EPC STORMWATER REVIEW COMMENTS ARE  
SHOWN IN ORANGE BOXES WITH BLACK TEXT

**FINAL DRAINAGE REPORT  
FOR  
FOREST LAKES FILING 7  
EL PASO COUNTY, COLORADO**

**December 2021**

Job no. 1175.70  
PCD File # SF-21-49

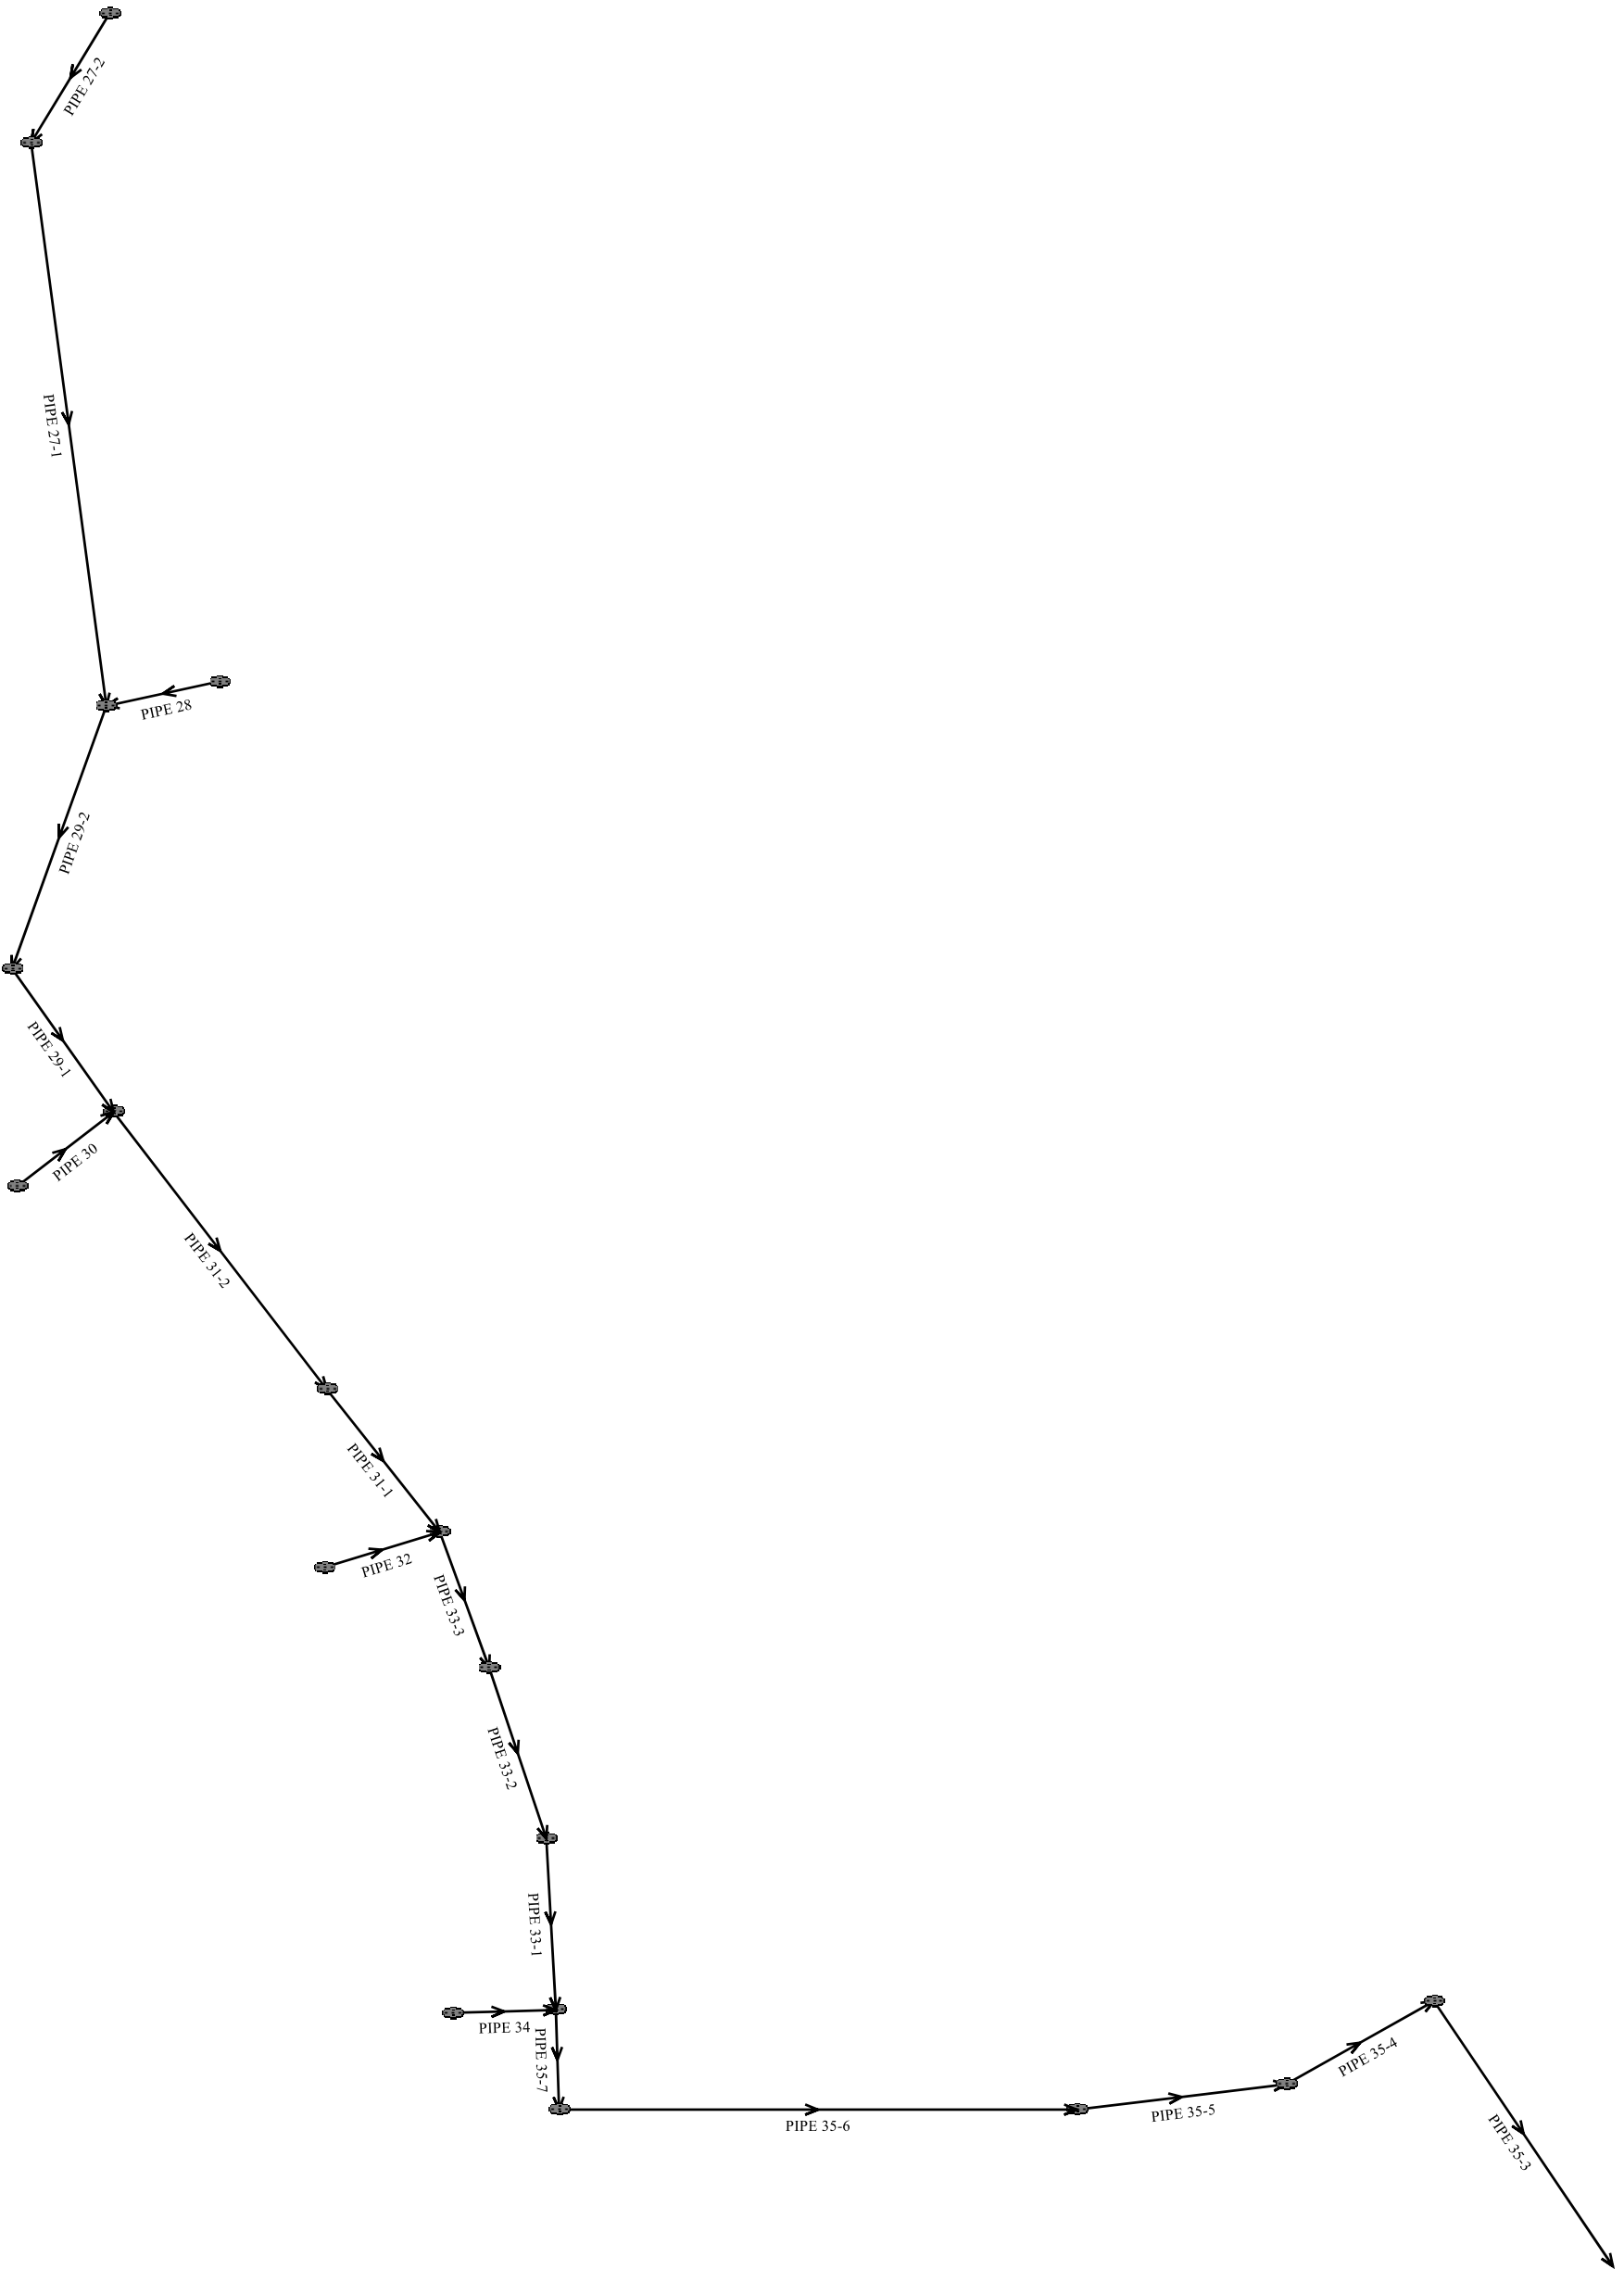
Unresolved-Please provide deviation request for velocities larger than 18 fps on new pipes.
